RAILWAYS AND PUBLIC WORKS:

REPORT OF THE ROYAL COMMISSION.

ROYAL COMMISSION
ON
RAILWAYS AND PUBLIC WORKS.

REPORT
OF
THE COMMISSIONERS,

SECTION OF PIER NO. 7

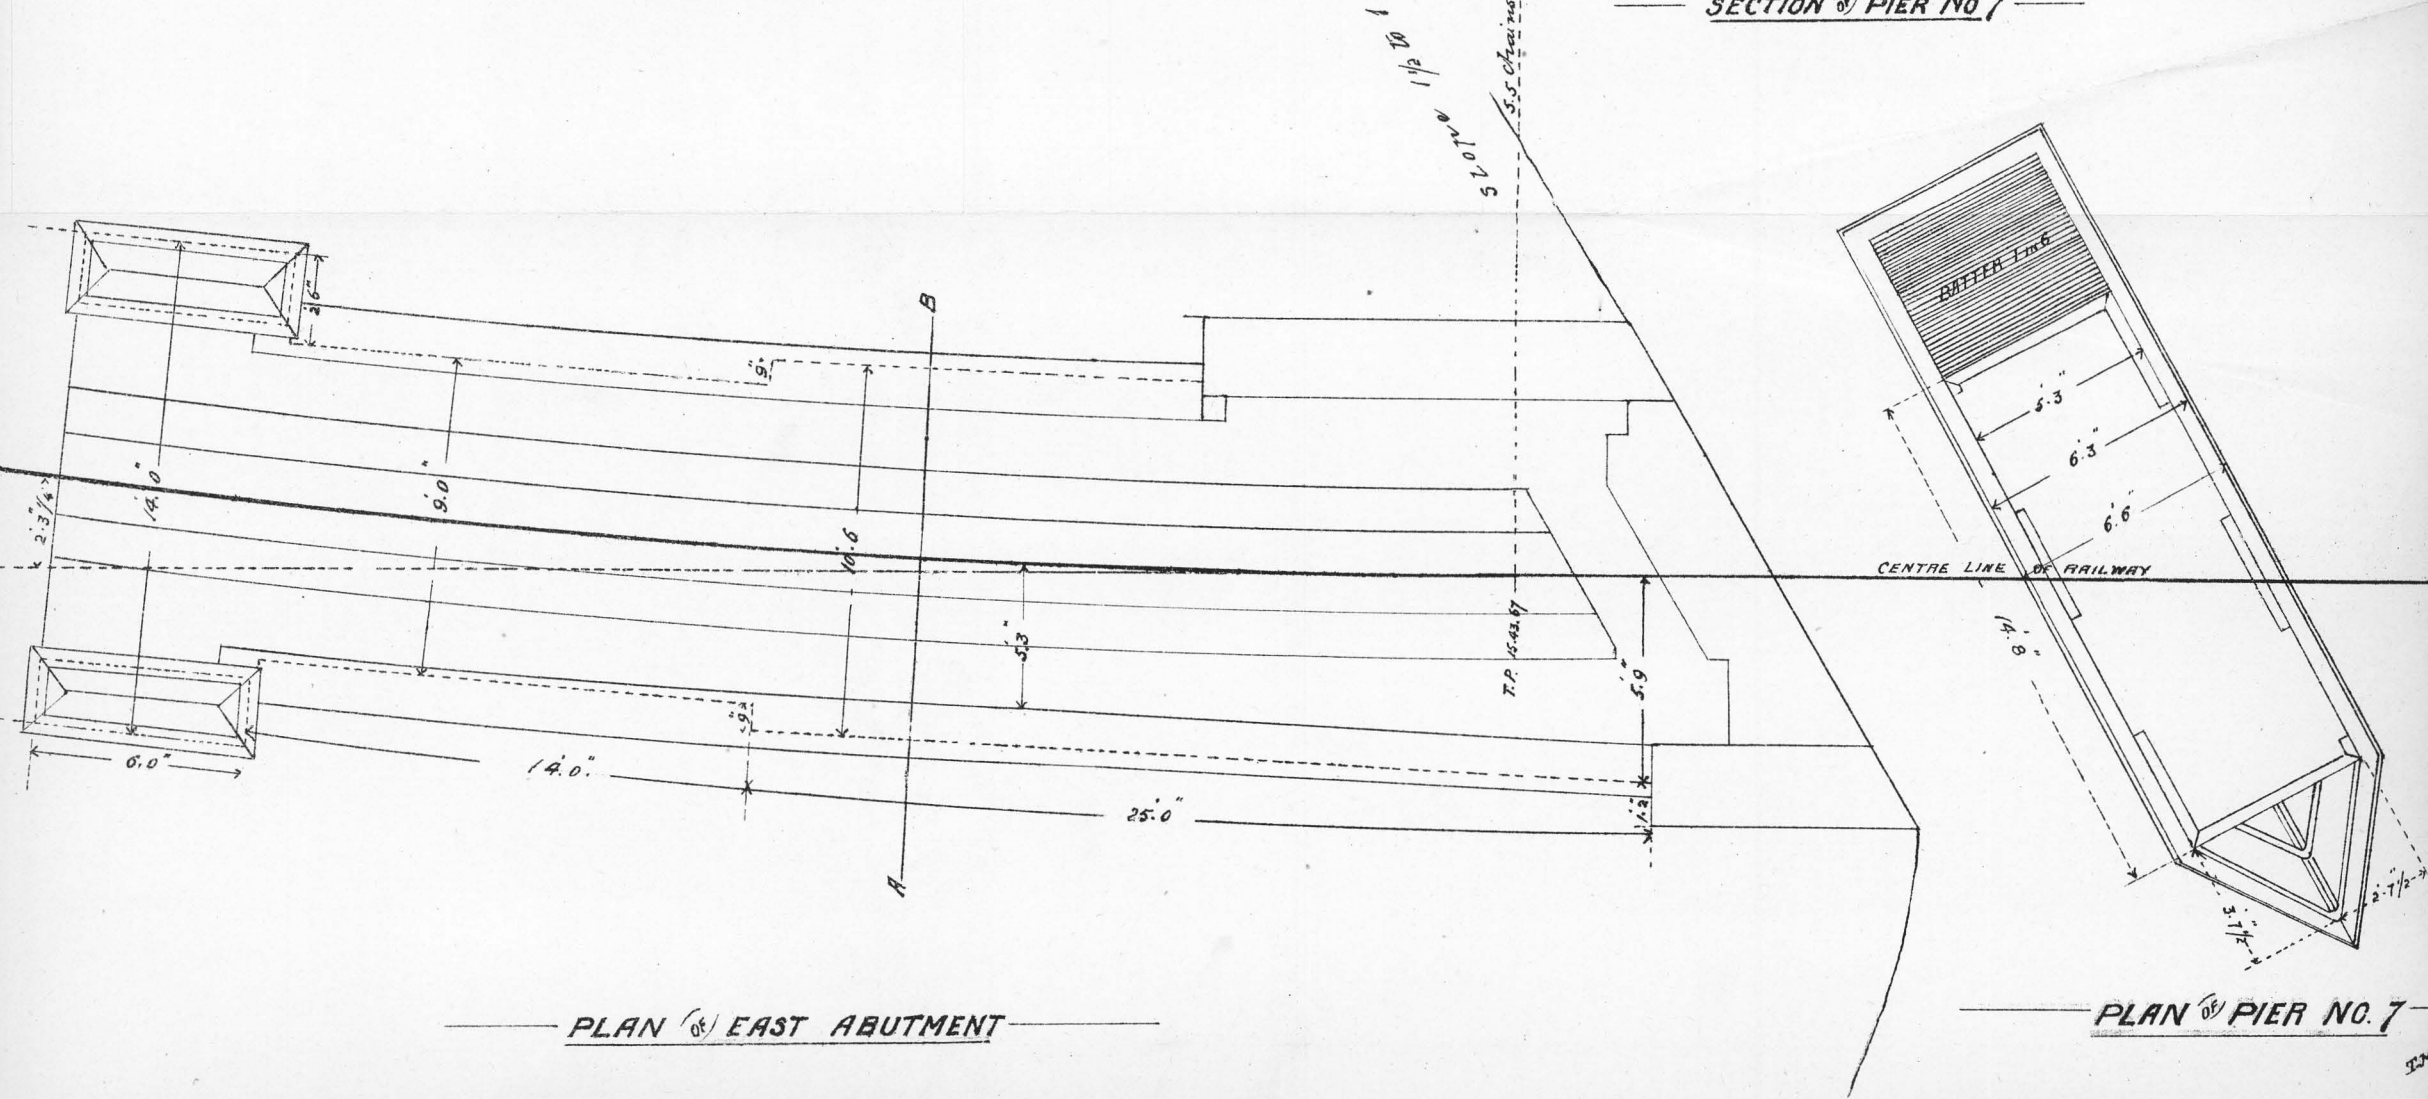
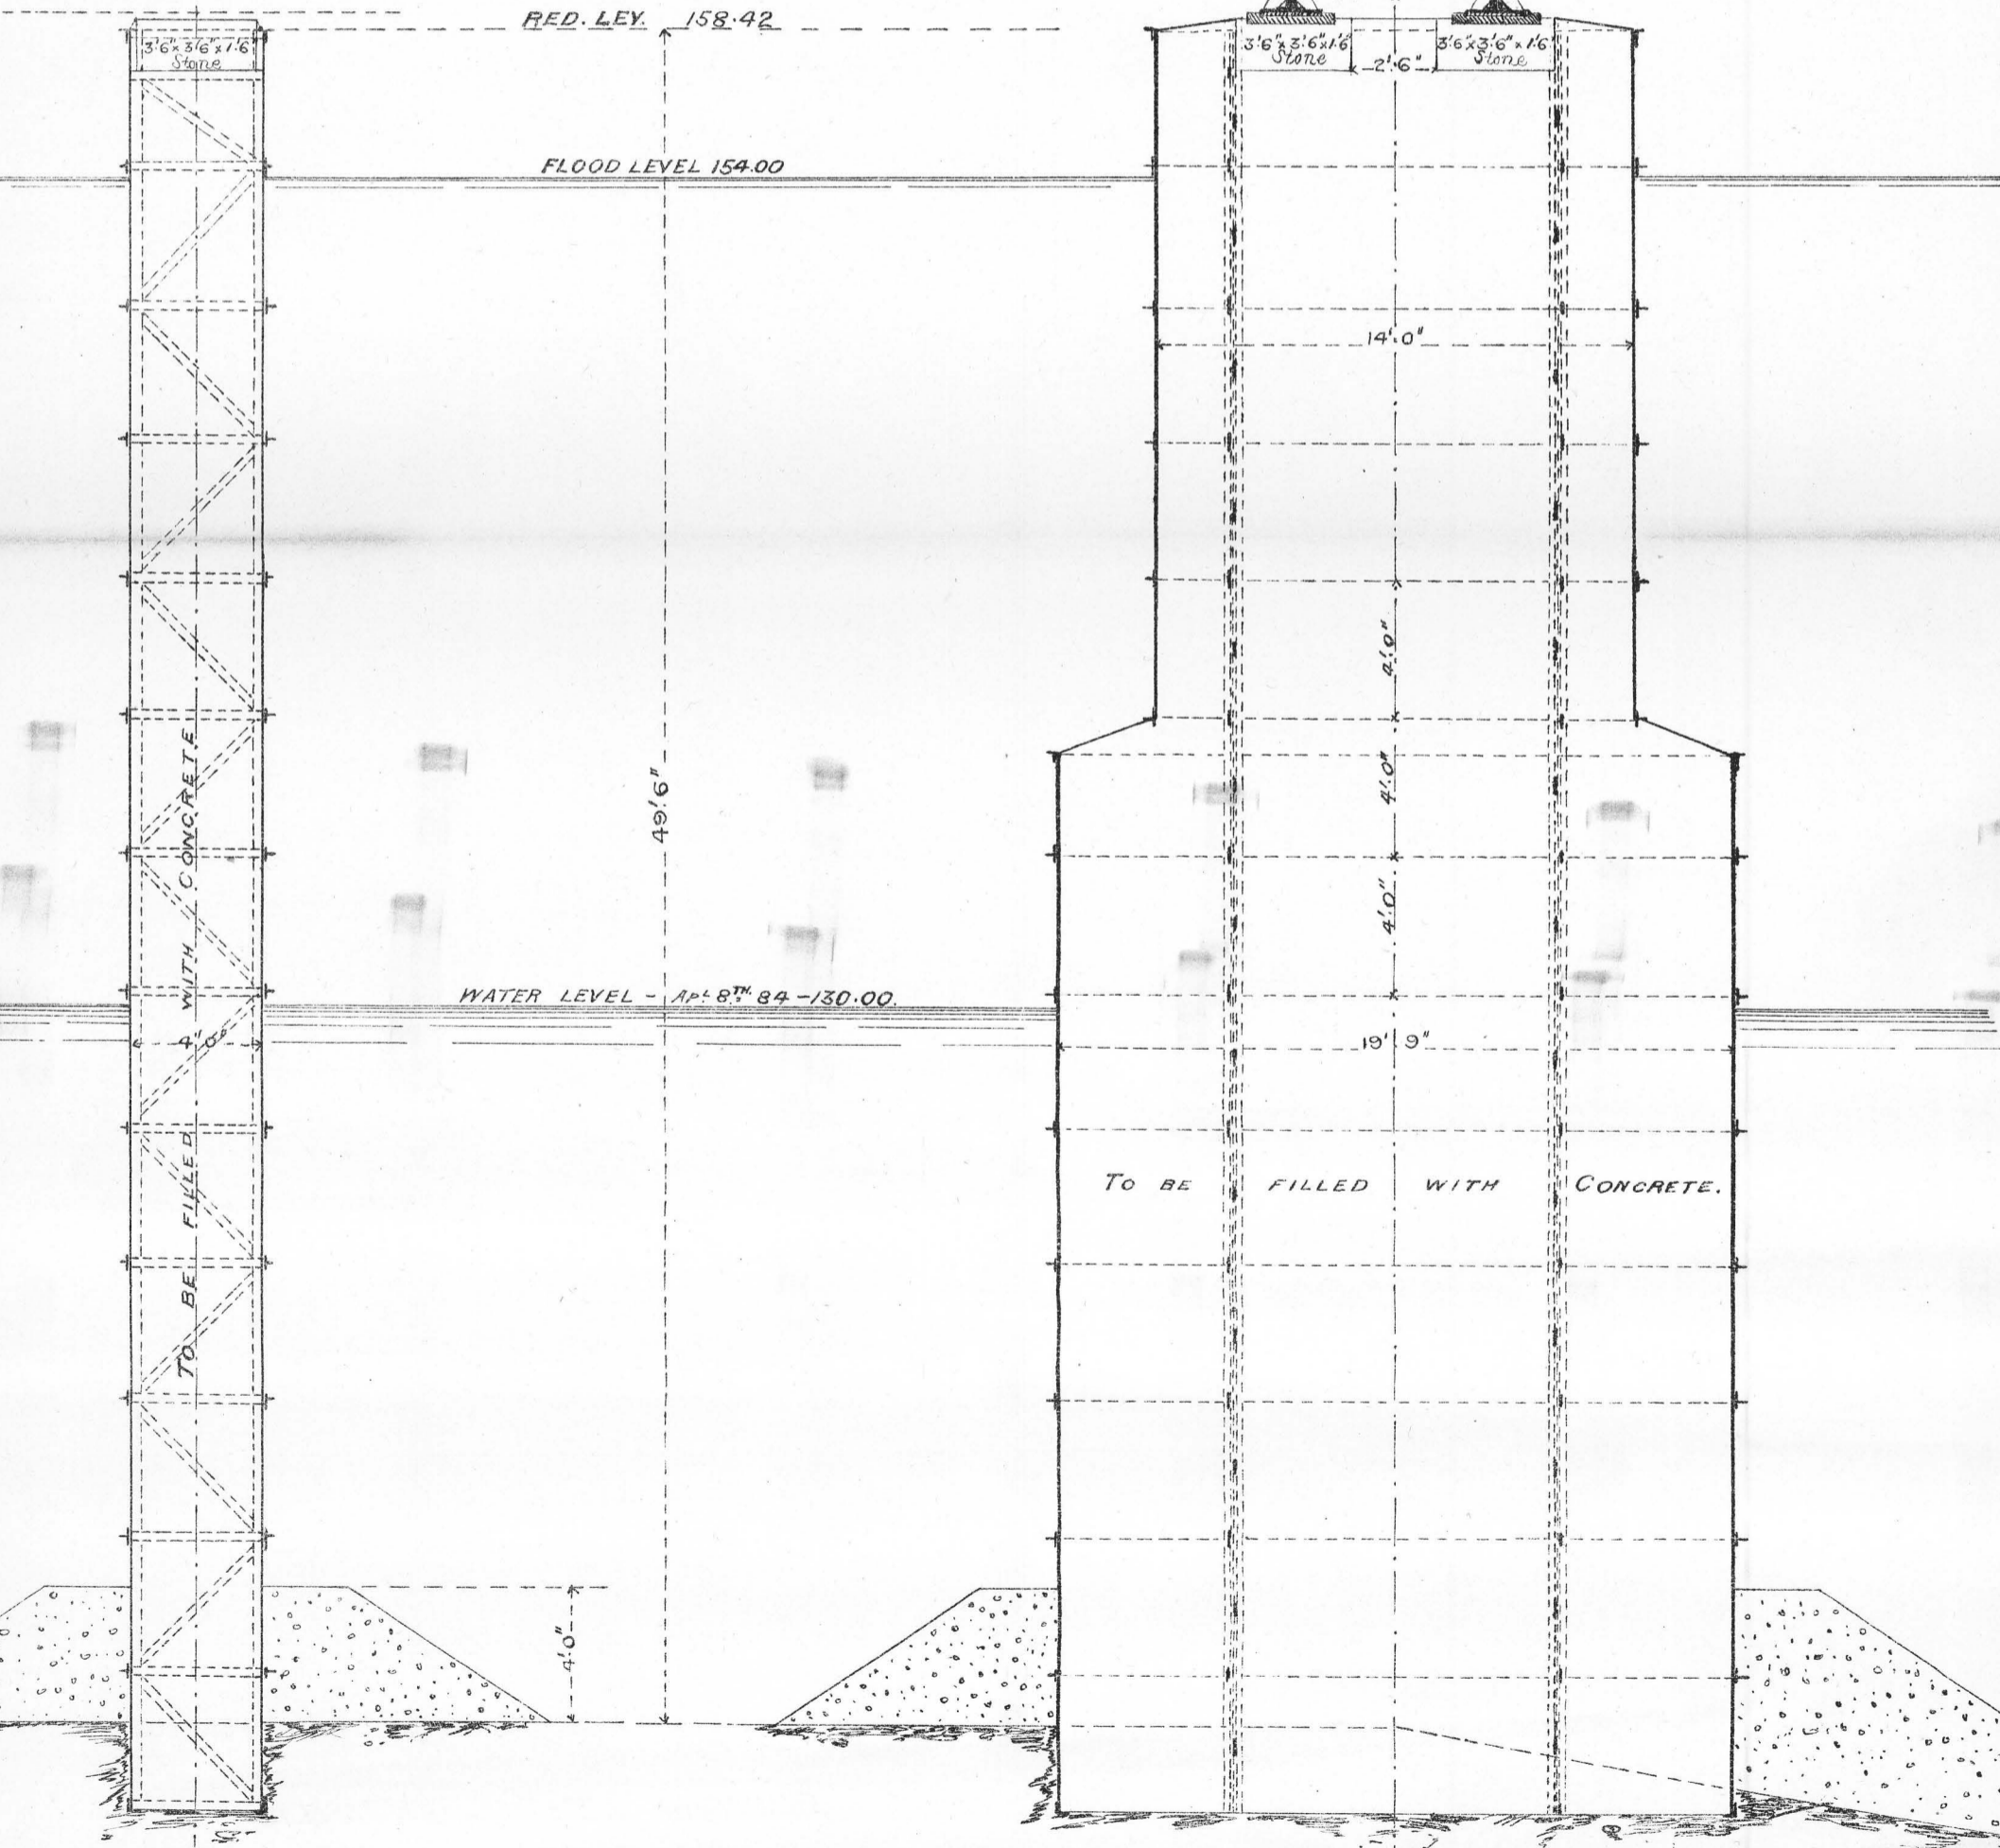
The design of the girders show them to be strong enough, and calculated to do more than can be required of them; but the manner in which it is proposed to fix them on the masonry; the small distance they are spaced apart, making their base only equal to their height; the want of strong external stays to the girders on the piers; the absence of diagonal bracing to the upper members of the girders; and the neglect to provide any means of fastening the timber floor to the upper bed-plates, constitute grave defects in the design.

We disapprove of the proposal to weaken the superstructure of Nos. 1 and 3 bridges by widening the timber-deck from 8 feet to 14 feet, which the Engineer-in-Chief (question 2161) proposes with the view of forming a combined track for road and rail traffic. This means to build a pier about 60 feet in height, and on this to fix two girders 6 feet apart, and to secure to these girders a timber floor 14 feet wide, forming a roadway with an overhang of 4 feet outside the web of the girders. Such a design would be condemned by any practical builder as deficient in the elements of stability and correct proportion.

To add to the risk of heavily laden trains safely crossing these bridges, the plan and section show that the approaches to No. 1 bridge are by descending inclines on sharp curves. In addition, therefore, to the weight of the rolling load, the girders have to resist the momentum of the train caused by the inclines and the centrifugal force brought into play by the action of the curves.
